Report on Current Conditions RCRA Facility Investigation

**Chemical Waste Management
Vickery, Ohio**

December 1994 REVISED ~~APRIL~~ 1995

Chemical Waste Management, Inc.
Response to Notice of Deficiencies (NODs)
RFI Report on Current Conditions

REV.	DATE			DRN BY	APP BY
DATE: DECEMBER, 1994		PROJECT NO. 38627	SCALE: NOT TO SCALE		
DES BY		PROJECT: RCRA FACILITY INVESTIGATION			
DRN BY JAT		SHEET TITLE:			
CHK BY RZ		100 YEAR FLOOD PLAIN			
REV BY					
APP BY					
		SHEET ____ OF ____		DRAWING NO.	
		FIGURE 3-2

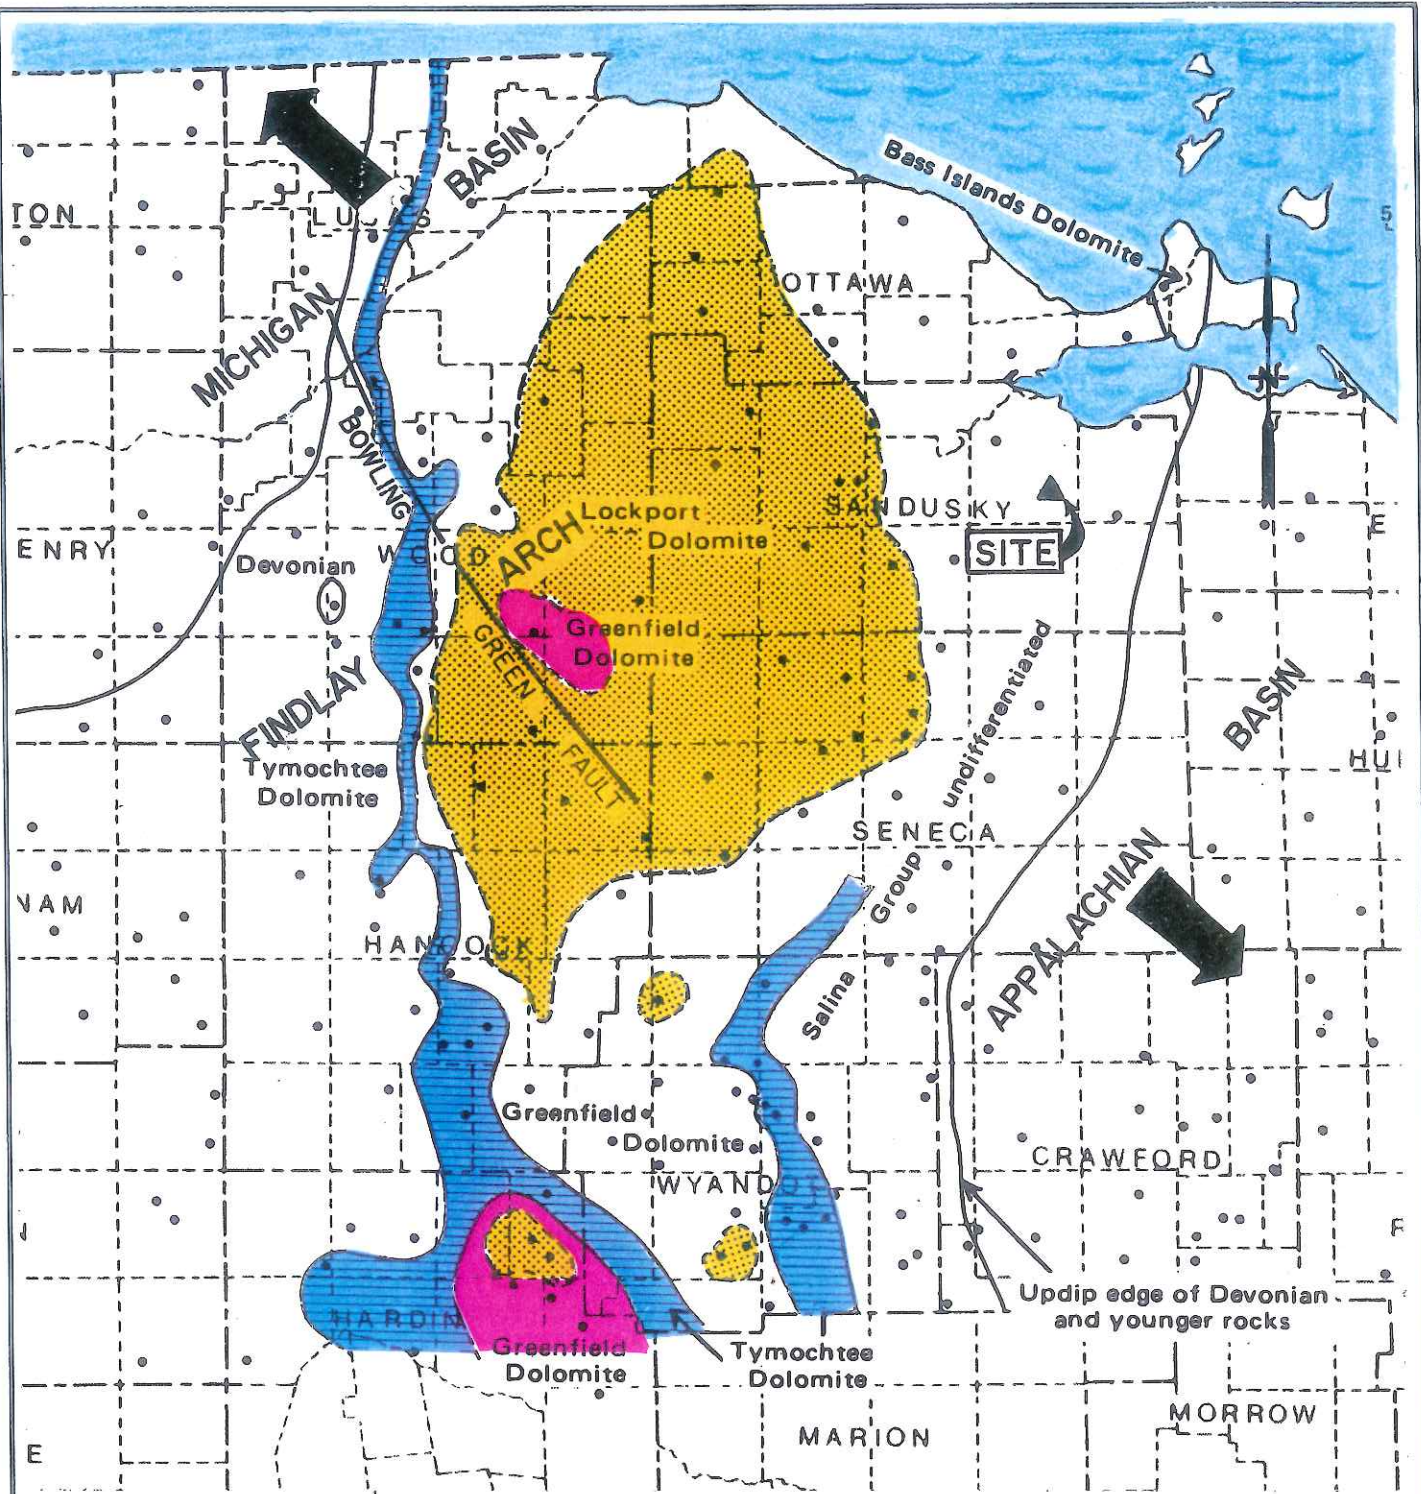
Comment 7

The source has been identified on this figure. However, no data points are available for this figure due to the fact that the figure has been adapted from the document title "Ground-Water Resources of Sandusky County, Ohio" completed as a master thesis by John A. Hoover, University of Toledo, dated December 1982. Figure 3-7 has been obtained from the Bowser-Morner Report titled "Hydrogeologic Assessment, Northern Ohio Treatment Facility" dated May 3, 1983. This figure is only referenced in the text to provide the reader with the general groundwater flow conditions in the carbonate aquifer as being north-northwest toward Lake Erie. This determination comes from the above reference report on the groundwater resources of Sandusky County and is only used to reference documented regional information on the regional groundwater flow direction. Groundwater flow within the bedrock aquifer has also been documented on-site using data from the facility's groundwater monitoring system. Three bedrock potentiometric surface contour maps are provided for review as Figures 4-9, 4-12 and 4-15. Data points are included on these maps.

FIGURE 3-3

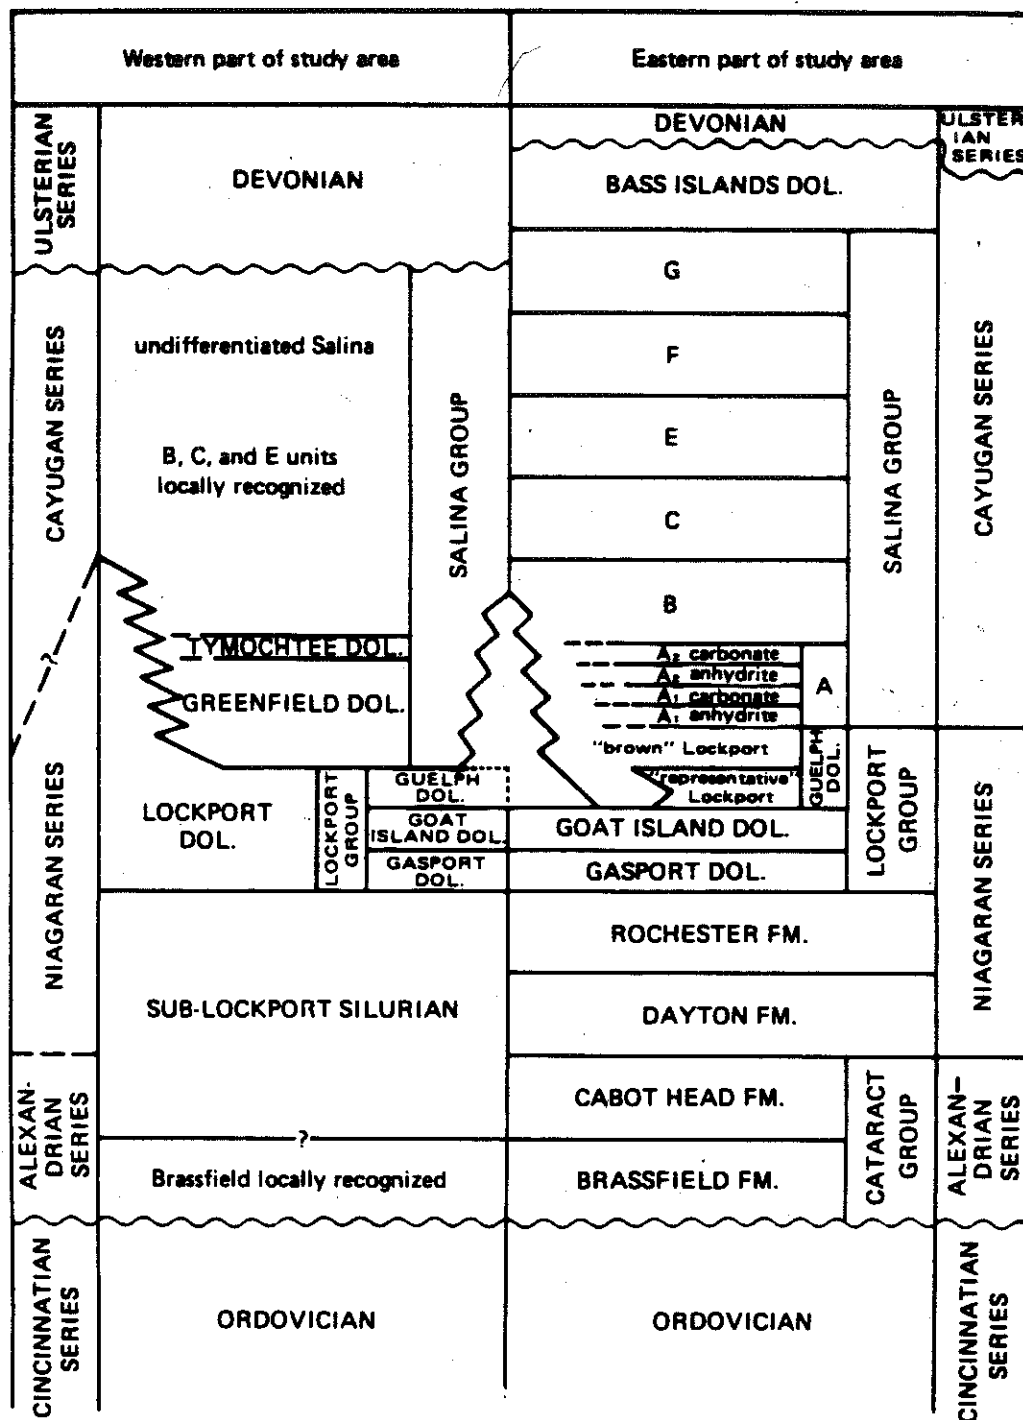
Comment 6

Figure 3-3 has been modified to include the legend.
